To: Amy Hodgen
From: Civil Engineering unit; Mark Pisani
Date: 1 June 2020
Subject: Application No: PLN19/0841
Description: AMCOR; Artisan West Precinct
Site Address: 81 Latrobe Avenue, Alphington

Drawings and Documents Reviewed

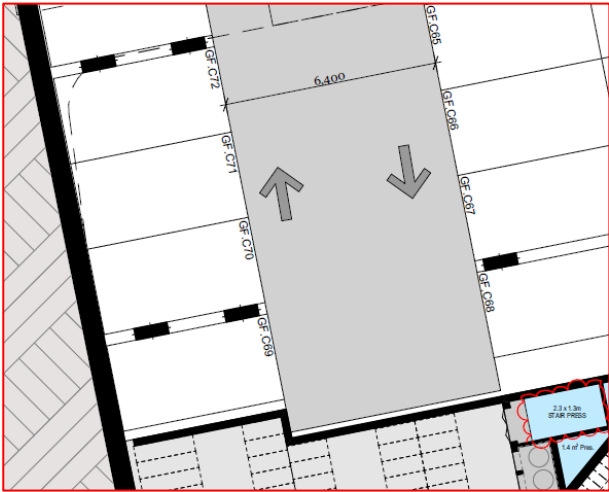
Item	Assessment
Access Arrangements	
Development Entrance	The 6.4 metre wide accessway into the Artisan West Precinct's car park satisfies <i>Design standard 1 – Accessways</i> of Clause 52.06-9.
Visibility	The pedestrian sight triangle of the accessway connecting to the main entry of the precinct is partially obstructed by a column. This obstruction is very minor and should not restrict a motorist's ability to see pedestrians walking along the north-south aligned footpath of the main entry. We are satisfied with the pedestrian sight triangle satisfies <i>Design standard 1</i> .
Headroom Clearance	Headroom clearances range from 2.2 metres to 3.0 metres and satisfy the Australian/New Zealand Standard AS/NZS 2890.1:2004.
Internal Ramped Accessways	The 6.4 metre clear width of the internal ramped accessway satisfies AS/NZS 2890.1:2004.
Car Parking Modules	
At-Grade Parking Spaces	The dimensions of the car parking spaces (2.6 metres by 4.9 metres) satisfy <i>Design standard 2 – Car parking spaces</i> of Clause 52.06-9.

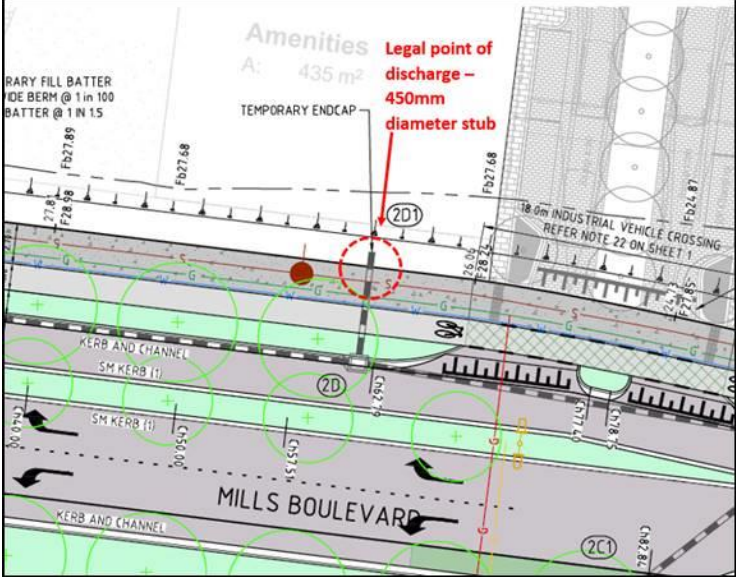
Tandem Parking Sets	The lengths of the tandem parking sets have been provided at 10.4 metres and satisfy <i>Design standard 2</i> .
Aisles	The 6.4 metre wide aisles satisfy <i>Table 2: Minimum dimensions of car parking spaces</i> .
Column Depths and Setbacks	Columns have depths of 1000 mm and have been set back from the aisles by 250 mm, and are located outside parking space clearance envelopes as required by <i>Diagram 1 Clearance to car parking spaces</i> of Clause 52.06-9.
Clearances to Walls	Not dimensioned on the drawings.
Blind Aisle Extension – <i>Ground Floor Plan</i>	The blind aisle extension adjacent to spaces GF.C ⁸ and GF.C ⁶⁹ has not been dimensioned.

Item	Details
Clearances to Walls	Clearances for spaces adjacent to walls are to be dimensioned on the drawings.
Blind Aisle Extension – Ground Floor Plan	<p>The blind aisle extension at the south west corner of the Ground Floor car park is to be dimensioned.</p>
